PRODUCT CHANGE NOTICE

PCN#23-002**NOTIFICATION DATE: January 6, 2023****MODELS AFFECTED:**

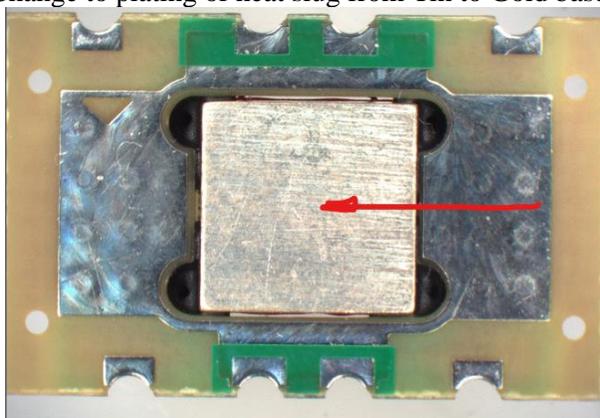
Change to plating of heat slug from Tin to Gold based plating (see red arrow for bottom side location of change)

**EFFECT OF CHANGE:**No change to FIT (Dimension) or FUNCTION (Performance)
Change to FORM (Appearance),**REASON FOR CHANGE:**
